FED. ROAD DIST. NO.	STATE	FED. AID PROJ. NO.	FISCAL YEAR	SHEET NO.	TOTAL SHEETS
HAWAII	HAW.	STP-0440(5)	1994	13	23

DRAINAGE PLAN

MANELE ROAD RESURFACING
Vicinity of Lanai City towards Manele Bay
Project No. STP-0440(5)

"AS-BUILT"

STA. 164+50± LT. & RT.
Construct: Standard CRM Headwall
Install: 30" CSP, t = 0.109 inches

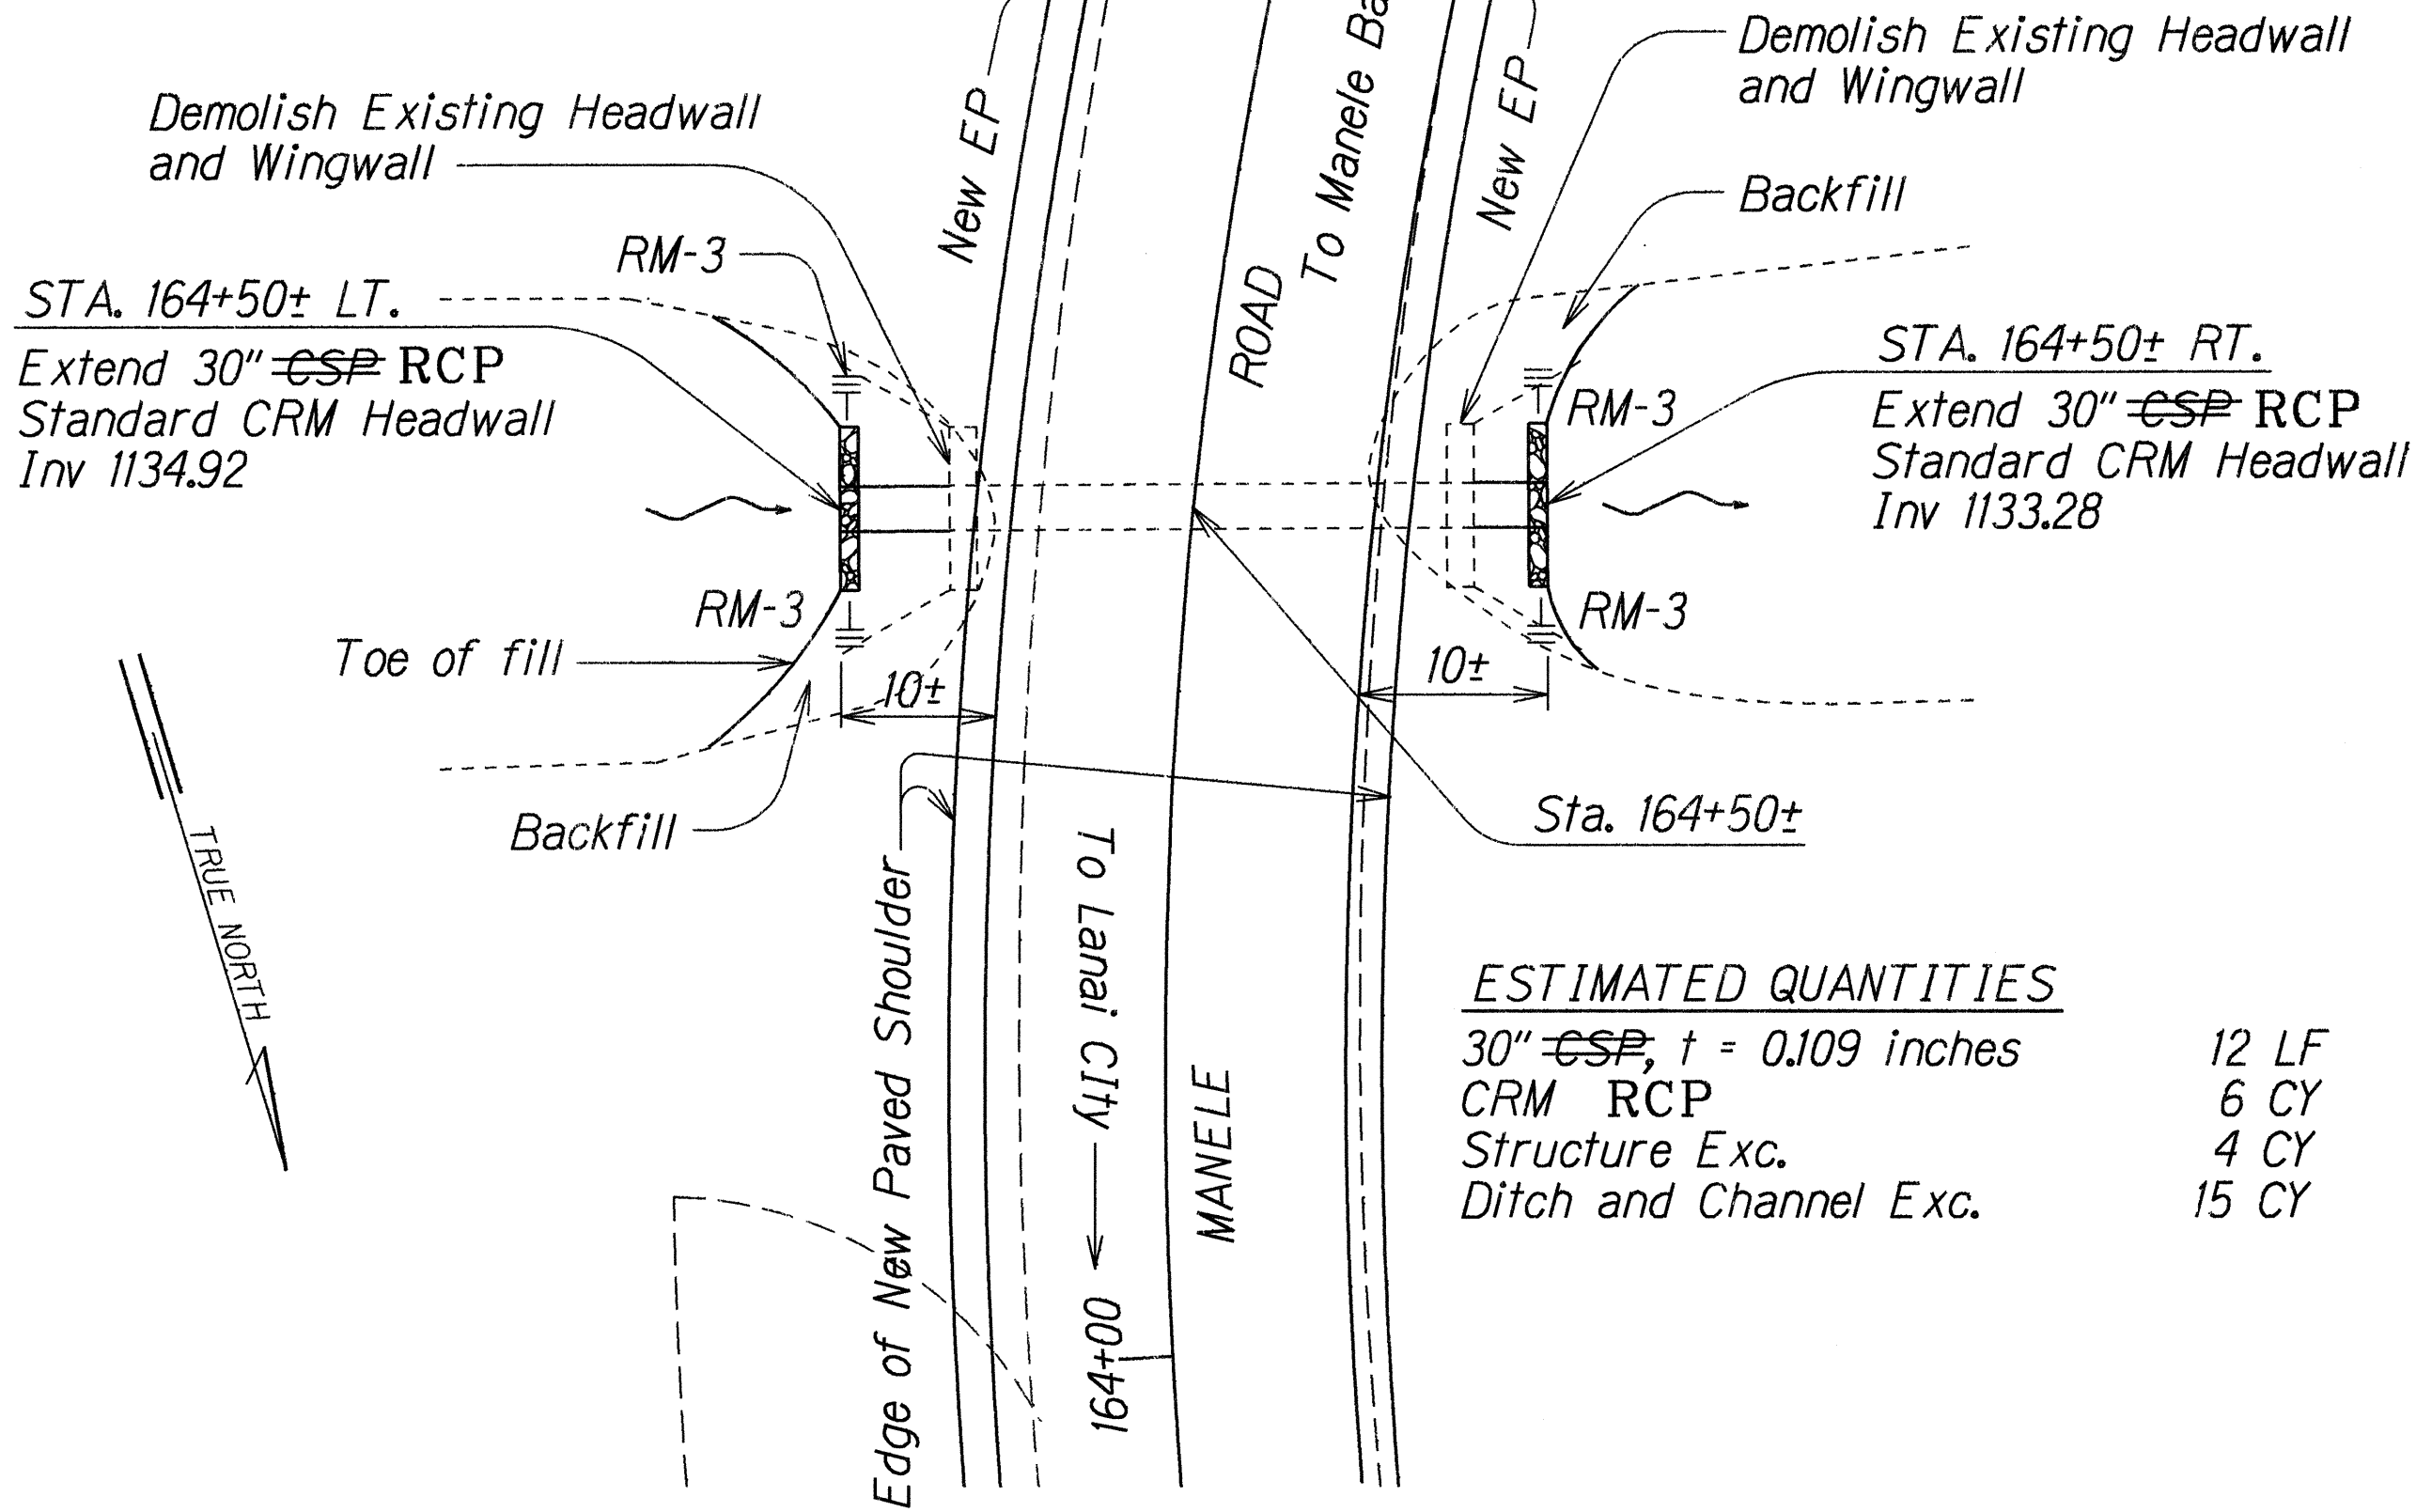
Delete Headwall and Install New GDI, Modified 61614

STA. 156+85± LT.
Extend 30" CSP RCP
Standard CRM Structure
(See Std. Plan H-16)
Inv 1135.4±

STA. 156+85± LT.
~~Construct Standard CRM Headwall and Wingwall~~
Install: 30" CSP, t = 0.109 inches RCP

6/2/94 Install culvert @ outlet Sta. 156+50 per Addendum No. 1
